**EASTSOUND SEWER AND WATER DISTRICT
WASTEWATER TREATMENT PLANT UPGRADE – PHASE 2**

**ADDENDUM NO. 3 (22 pages total)
Issue Date: March 11, 2025**

SHEET	S3.1	DATE	1-16-2025
PAGE	64 OF 91	SCALE	AS SHOWN
		JOB NUMBER	Wilson: 2023-123 KW: 23093

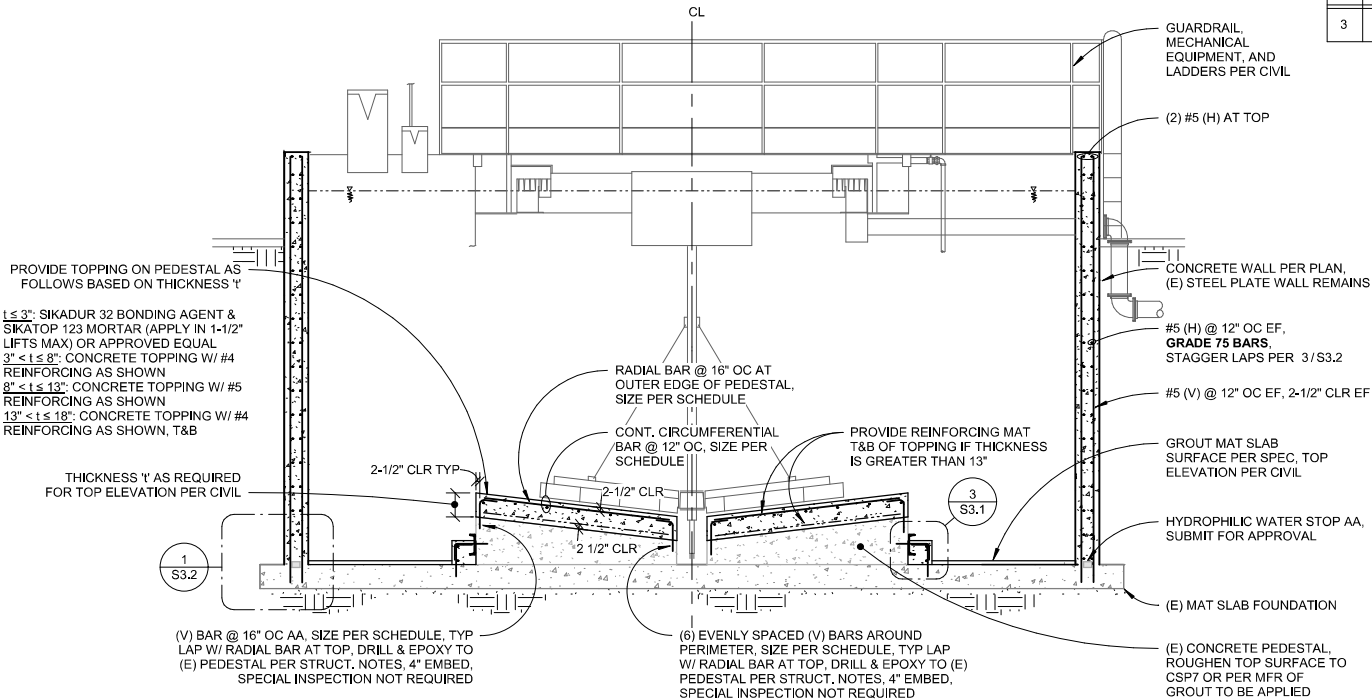
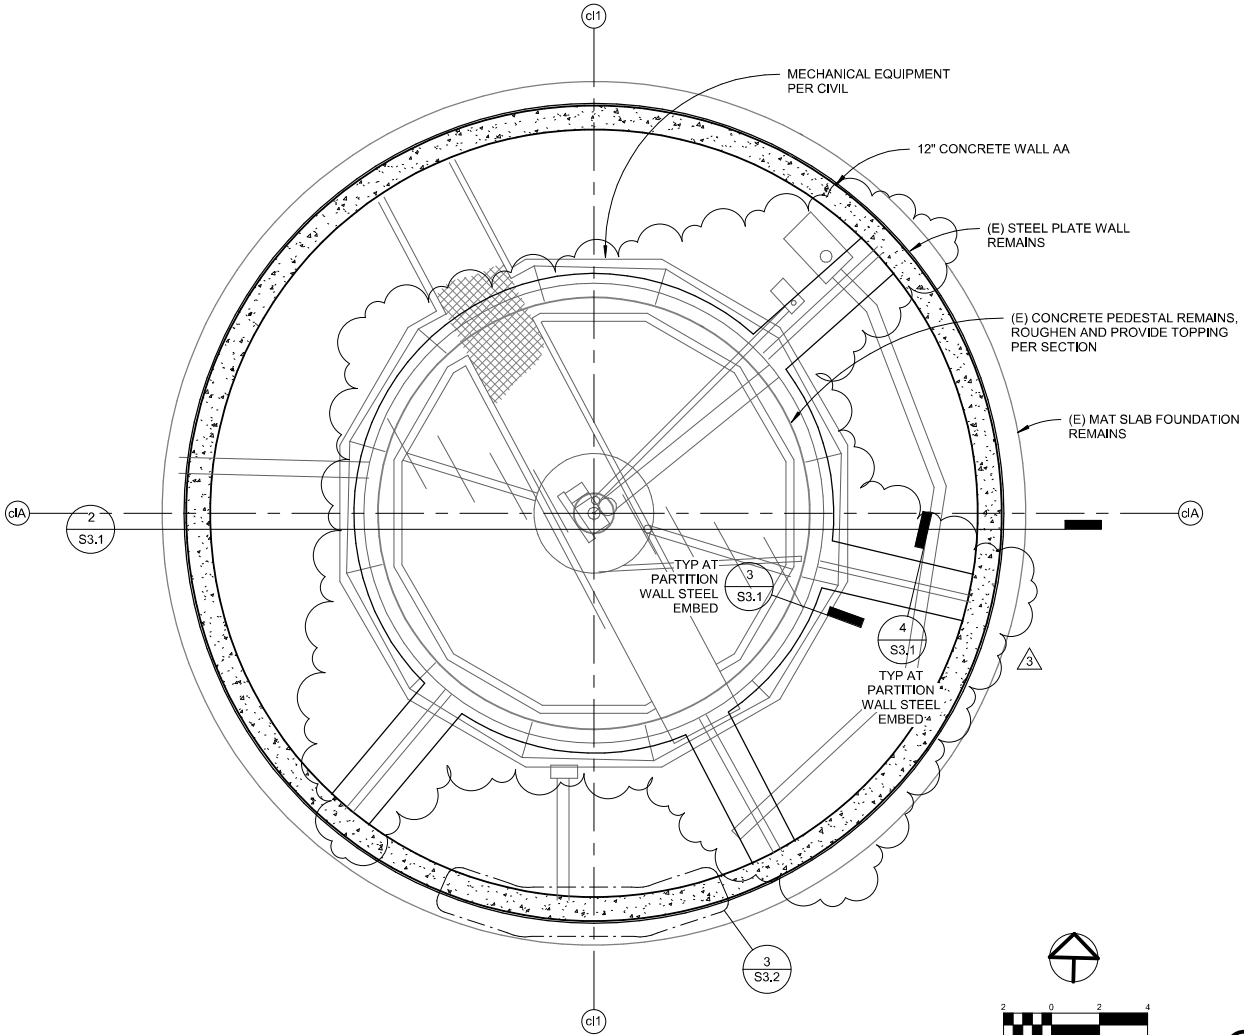
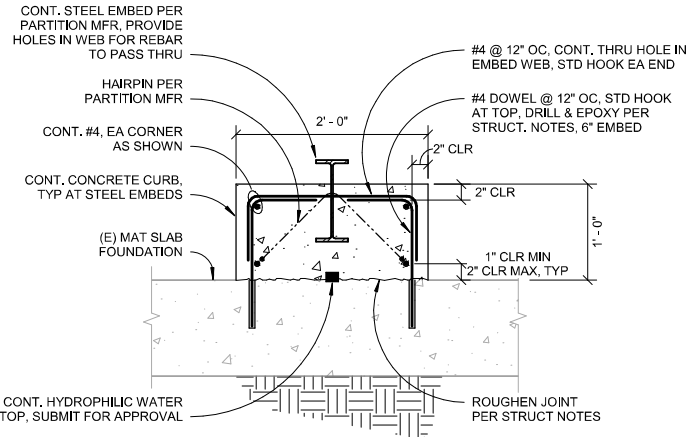
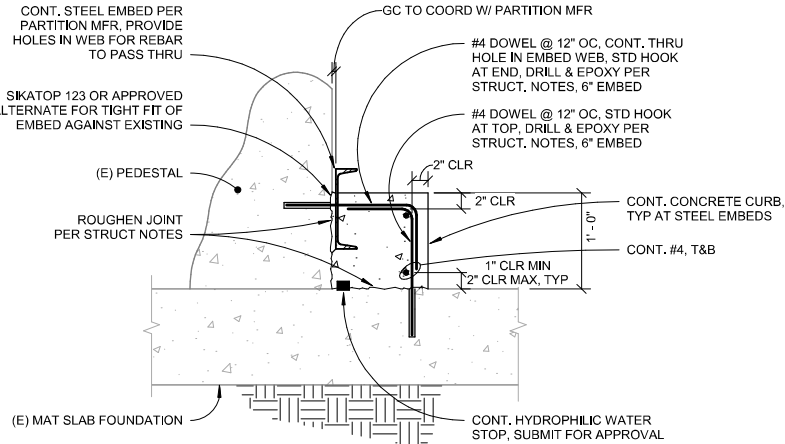
Updated sheet S3.1 is attached. This sheet shows the addition of concrete curbs for steel embedments that will need to be placed directly on top of the existing concrete foundations for Train #1 and Train #2. Note: steel embedment elevations will be raised 1-ft higher to accommodate the new concrete curbs. Adjust steel dimensions, as needed, for partition walls, vertical embedment height, etc. Also, note that the following modifications will be needed:

- Saw cut trenches and remove existing grout/concrete in the existing pedestal, as needed, so new RAS & WAS piping can be installed. Bed piping with concrete. Seal all voids.
- Remove existing grout/concrete at center, as needed, so new clarifier torque tube anchor (instead of a J-Bolt) can be drilled and epoxied into the existing 12" thick concrete slab.
- Install new bottom center cone (from Biological Treatment System supplier), connect piping, connect torque tube assembly, and patch voids with concrete, as needed, so the final product matches the approved design configuration from the Biological Treatment System supplier.

E0.5

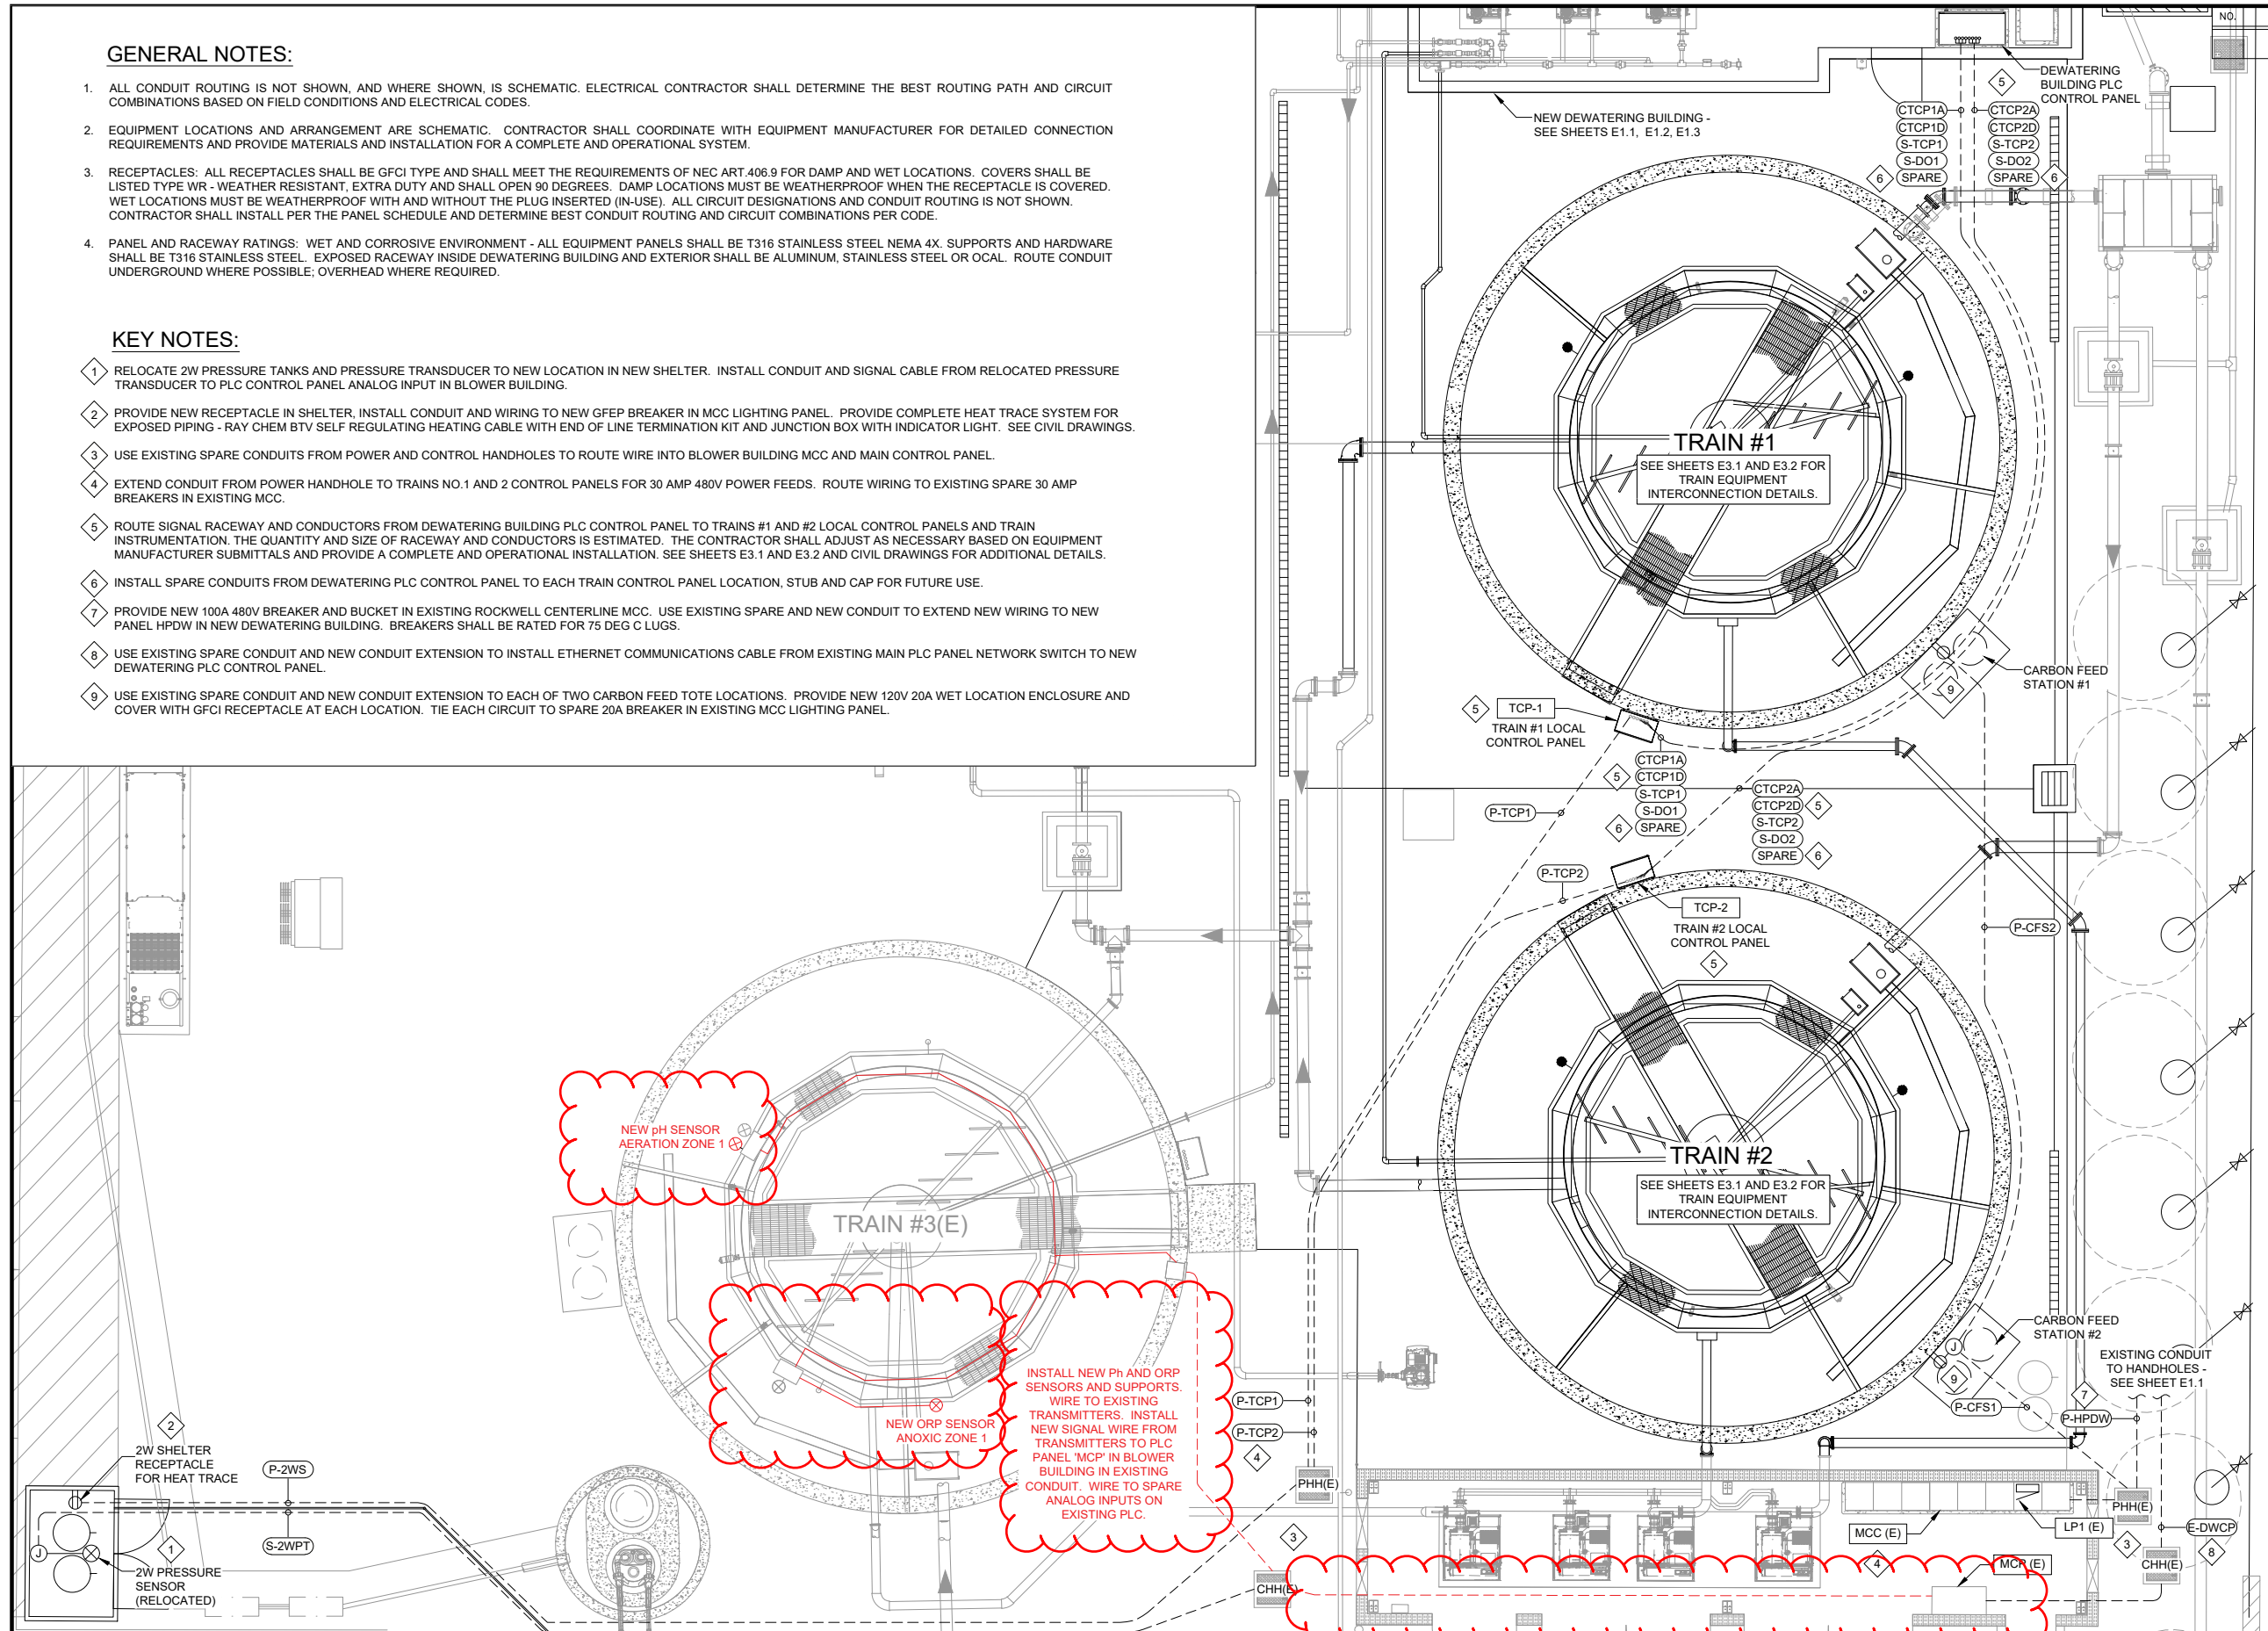
Treatment system provider to supply new pH and ORP sensors and supports for existing Train No.3. Contractor to install new sensors and wire to existing Hach 4500 transmitters, and install new signal wiring from existing transmitters in existing signal conduit to spare PLC inputs in panel 'MCP' in Blower building.

DATE	01-24-2025
SCALE	AS SHOWN
JOB NUMBER	2023-123
SHEET	E3.1
PAGE	75
OF	91

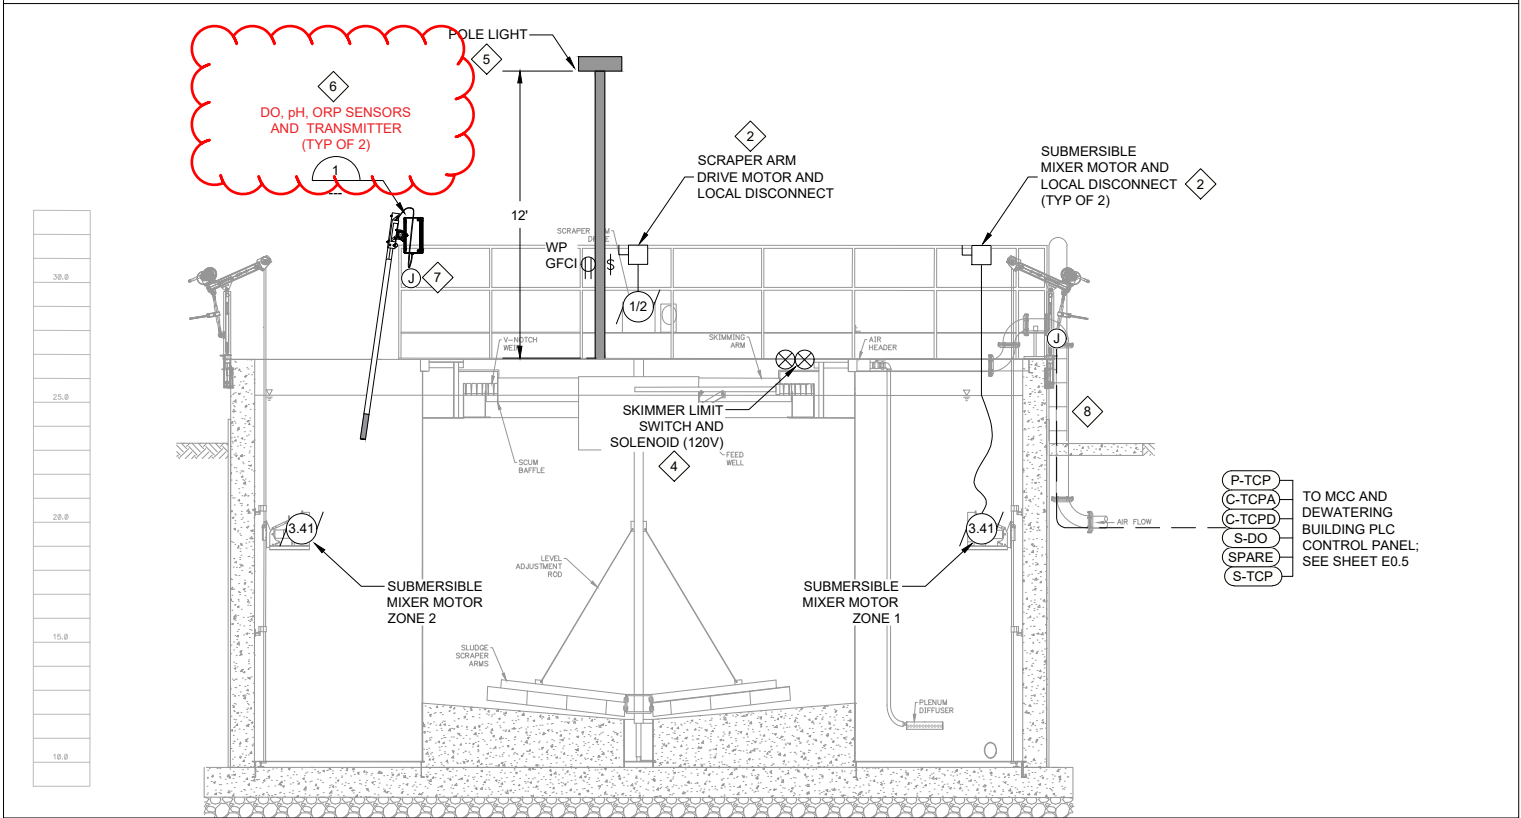
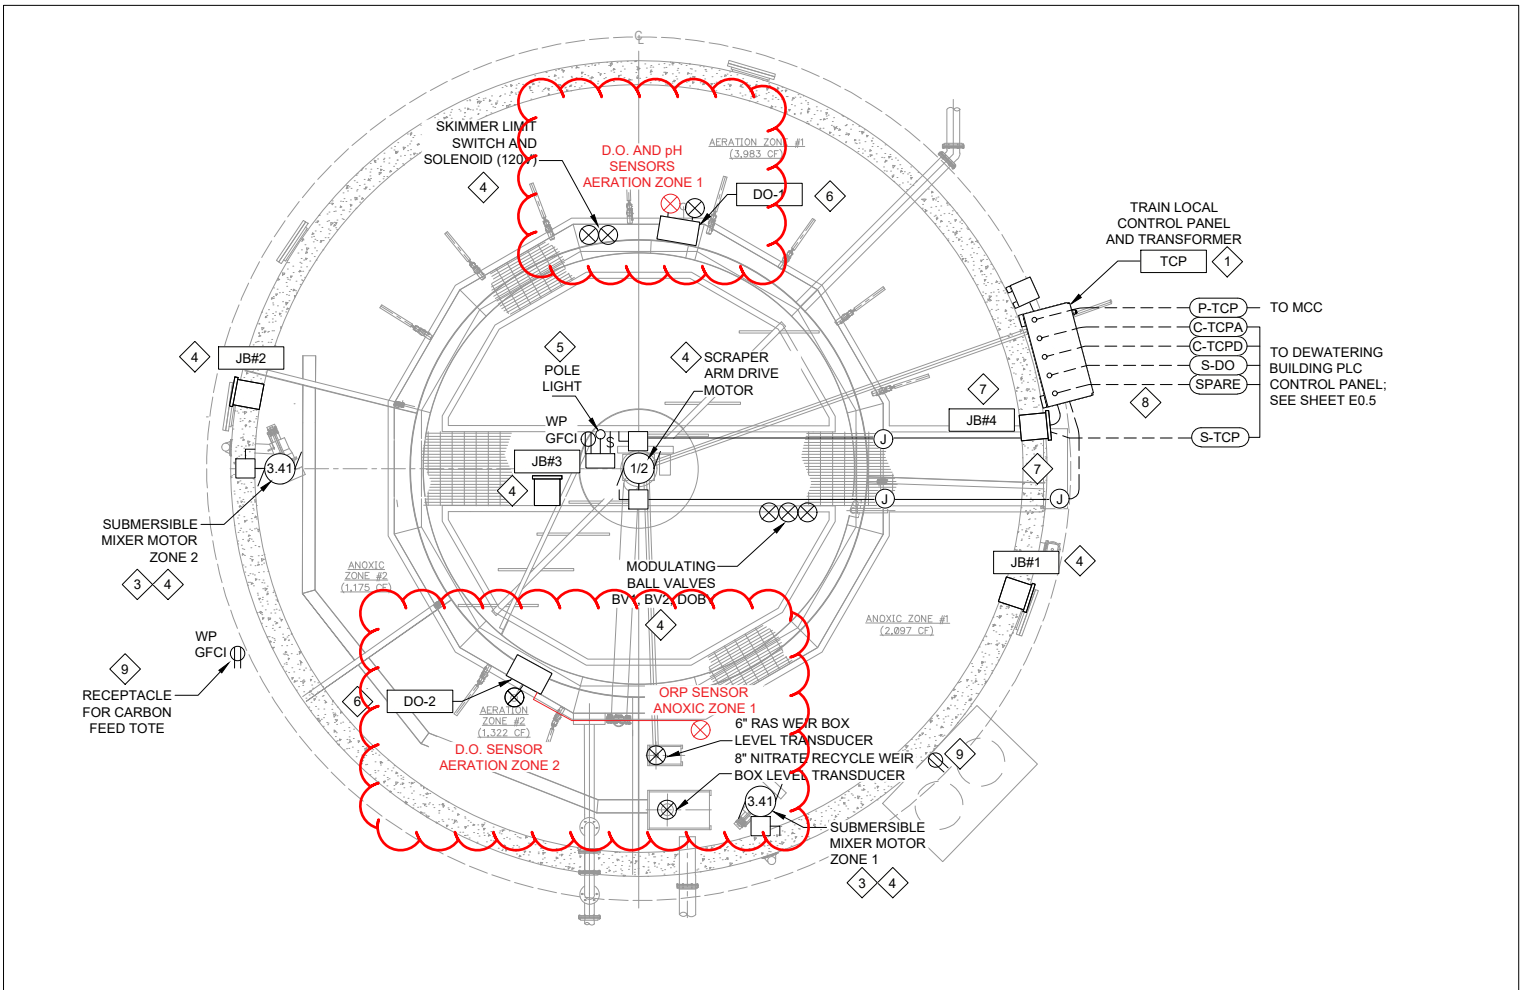
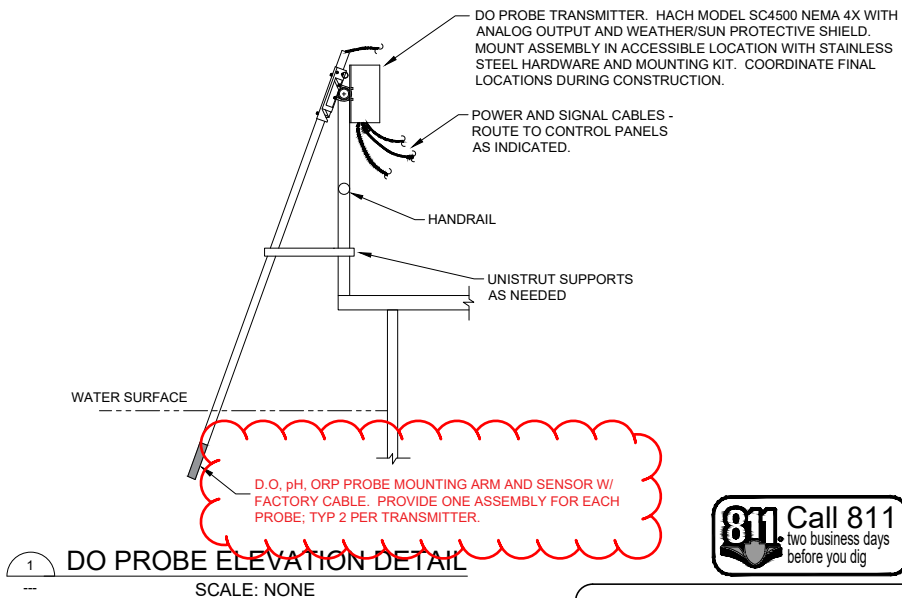
This sheet indicates the new pH and ORP sensors to be supplied by the treatment system provider and installed by the Contractor, typical for Trains 1 and 2.
